Studebaker SERVICE BULLETIN

NO. 236

1950

FIG. 1

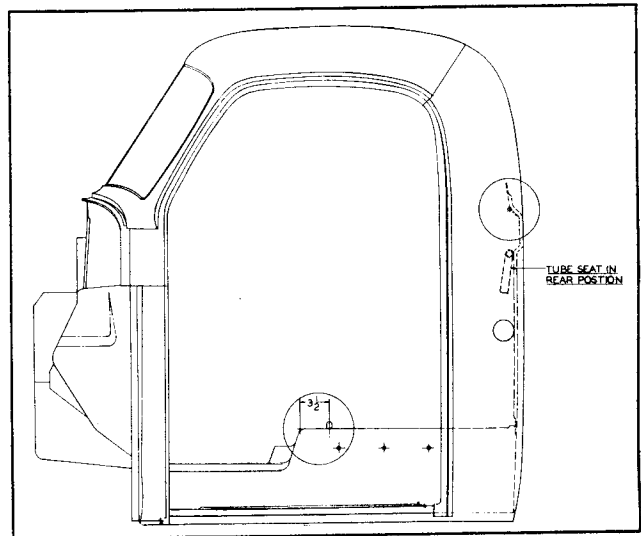
The new type adjustable seat, Part No. 653050 (LHC) or 653051 (RHC), can be installed in 2R Series cabs produced prior to the above serials (see Fig.1), by drilling ten holes in the floor pan, and bolting the new assembly in place. Location of the bolt holes is shown in Fig.2.

INSTRUCTION FOR INSTALLING ADJUSTABLE TUBE SEAT ON CAB ASSY 652873-REMOVE OR FLATTEN LEFT SIDE SEAT DOWEL 648643 AND PLACE TUBE SEAT ASSY (WITH SEAT TRACKS ADJUSTED TO REAR POSITION) IN CAB IN FURTHEST BACK POSITION & DRILL 10-11/32 HOLES IN FLOOR PAN THRU SEAT TRACK SUPPORT HOLES BOLT IN PLACE WITH ATTACHING PARTS AS SHOWN IN BILL OF MATERIAL.

FIG. 2

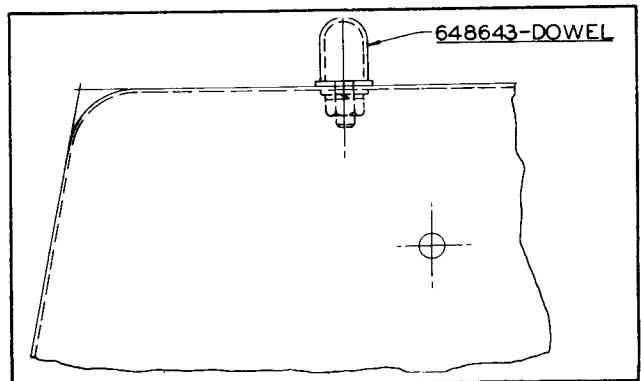
Should it be desired, the old type, three-position adjustable seat can be installed in 1950 production 2R Series trucks by addition of the dowels and the body halves of the hinges on the strainer as shown in Figs.2,3,5,6, and 7. Parts required, in addition to the seat cushion and back assemblies, are:

INSTRUCTIONS FOR INSTALLING CONVENTIONAL SEAT & BACK ON CAB ASSY-653014-ASSEMBLE 648643 SEAT DOWELS & 648611 SEAT BACK HINGES TO DIMENSIONS & ATTACHING PARTS AS SHOWN ON DRAWING & BILL OF MATERIAL. COVER ALL TUBE SEAT ATTACHING HOLES IN FLOOR WITH TAPE TO BLOCK OFF DUST LEAKAGE.

FIG. 8

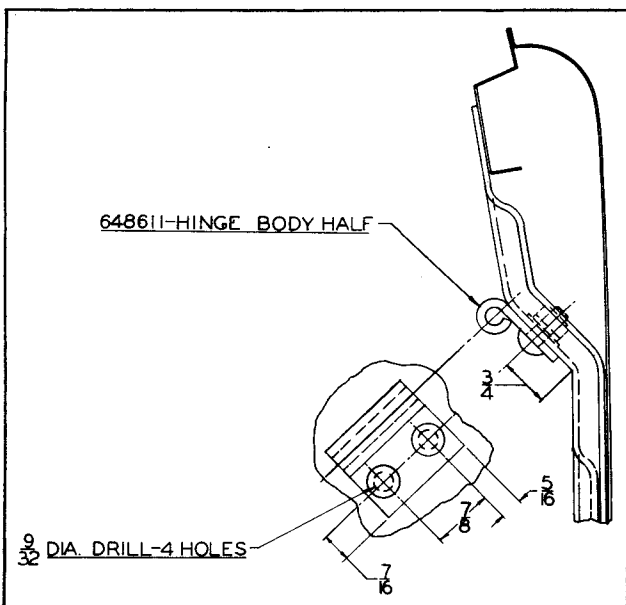
The two latches which lock the seat assembly in position must engage fully, to prevent possible rattles. An operating rod adjusted too loosely will cause a rattle between the rod and the seat frame, while a rod adjusted too tightly will prevent one latch from engaging fully, causing a rattle between the latch and tooth track. The adjustment is made at the point indicated in the accompanying illustration (Fig.8).
